Technical Service Bulletin

GROUP CAMPAIGN	NUMBER 22-01-011H
DATE FEBRUARY, 2022	MODEL(S) PALISADE (LX2)

SUBJECT: VEHICLE INSPECTION AND DRIVE PLATE REPLACEMENT
(SERVICE CAMPAIGN T7U)

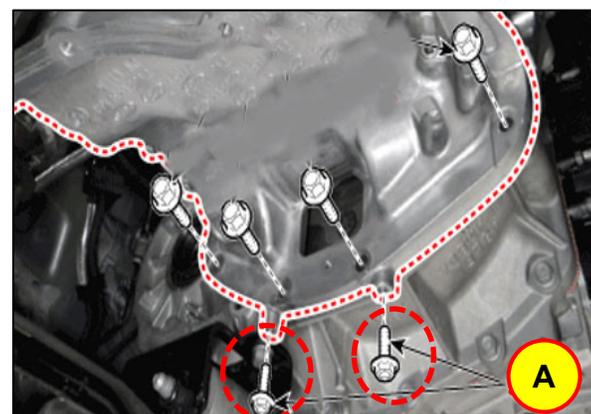
Depress the brake pedal and move the gear lever to the following gears and then check if a metallic noise is heard or not.

- 1) D, 10 seconds
- 2) R, 10 seconds
- 3) Repeat 3 times.

- If a metallic noise is **not** heard, the Service Procedure is complete.
